PERFORMANCE SPECIFICATION SHEET

SWITCHES, PUSHBUTTON, LIGHT EMITTING DIODE (LED) ILLUMINATED,
STANDARD, NIGHT VISION IMAGING SYSTEM (NVIS) AND SUNLIGHT READABLE DISPLAYS,
SPDT AND DPDT, LOW LEVEL TO 7 AMPERES, SEALED AND UNSEALED,
SOLDER AND COMMON TERMINATION SYSTEM (CTS) TERMINATIONS

This amendment forms a part of MIL-PRF-22885/111A, dated 5 September 2000, and is approved for use by all Departments and Agencies of the Department of Defense.

Figure 3, Delete and substitute with
"

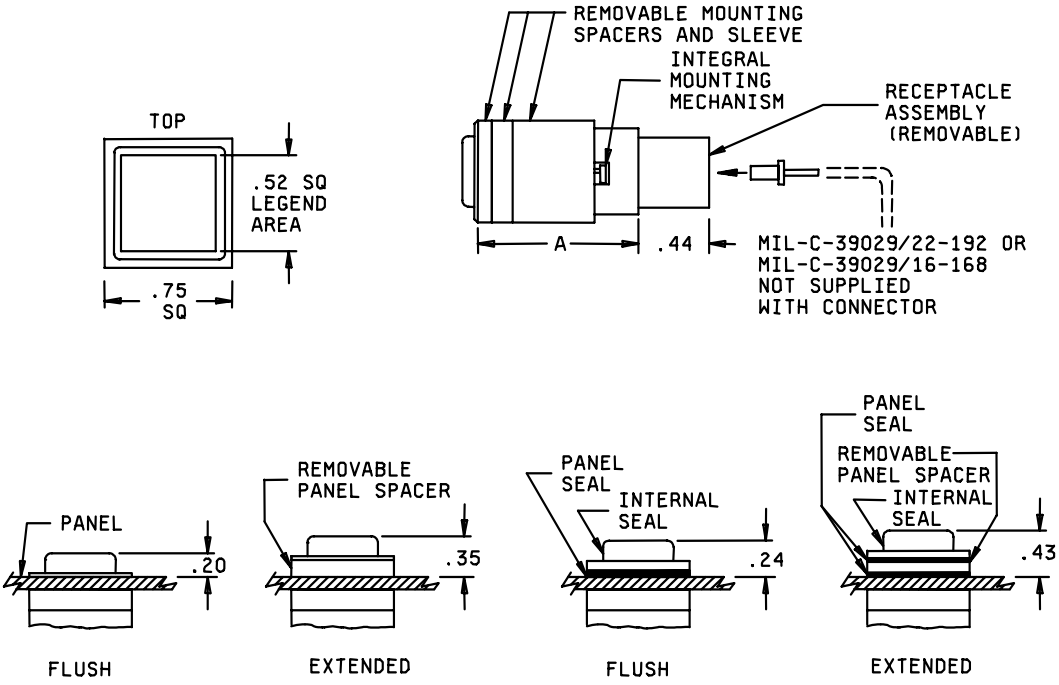
Contact Part Number	Dimension A (inches)
M39029/22-192	1.46
M39029/16-168	1.59

Figure 4, Delete and substitute with
"

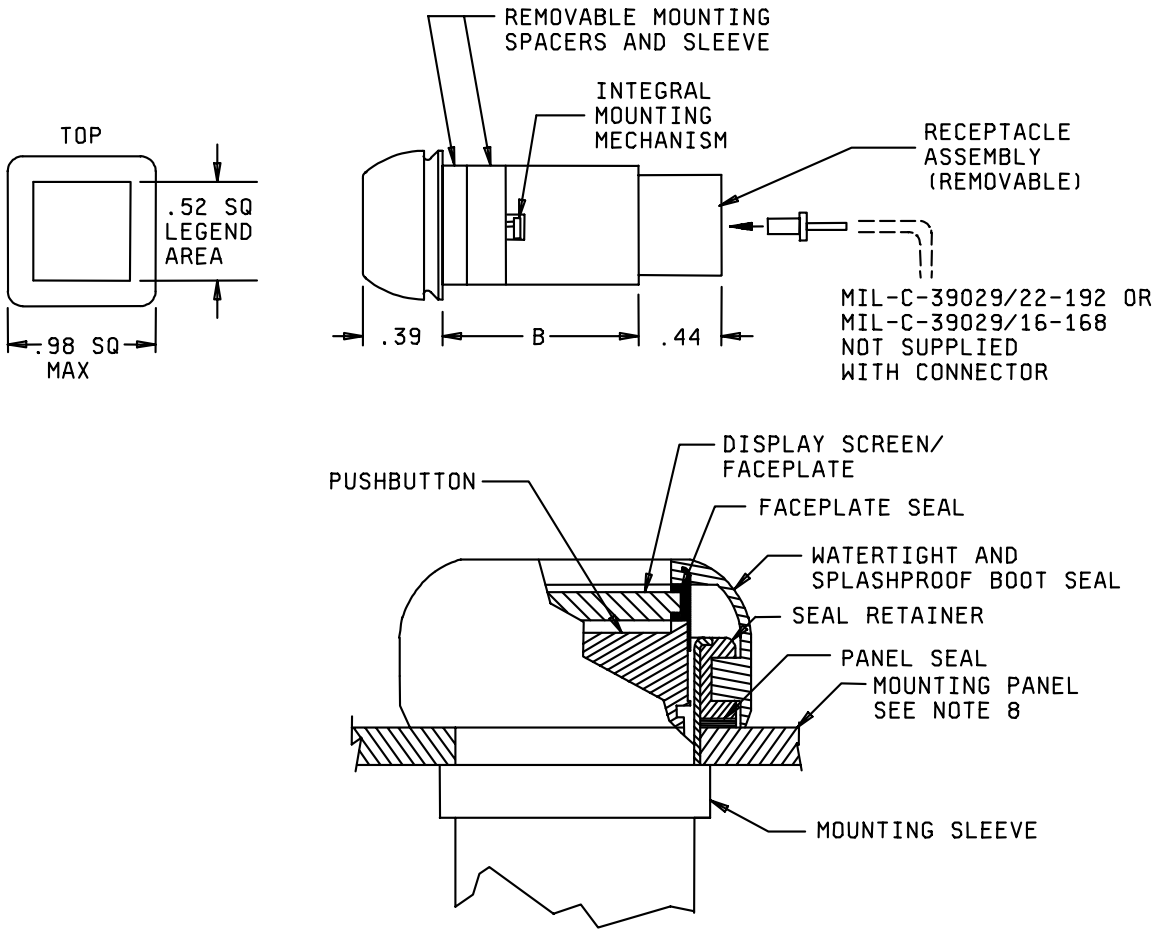
Contact Part Number	Dimension B (inches)
M39029/22-192	1.30
M39029/16-168	1.43
